I2PLCTR Errata

chargebyte GmbH

2024-01-08

Figure 2 Reflow Profile

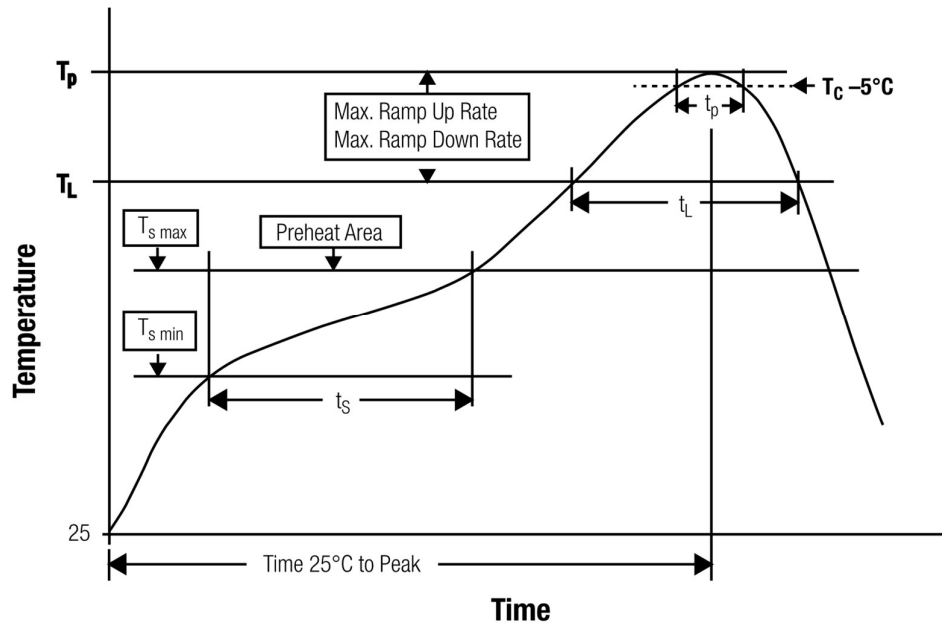
Please make an effort to minimize the temperature rise before ramp-up, while ensuring adherence to standard specifications. Through our comprehensive investigations and testing, we have identified a modification in the delta T over time for both soak time (t_s) and time to peak as depicted in the figure below, reduces the failure rates to an absolute minimum. Put more simply. Try to extend the time to peak temperature T_p as long as possible to ensure slow heating and avoid sudden expansion of water.

This setting has considerable potential for improving drying quality and avoiding problems caused by the rapid expansion of moisture in the components. If you allow sufficient time during the preheating phase, the moisture in the parts should dissipate completely. We recommend that you integrate these improvements into your processes.
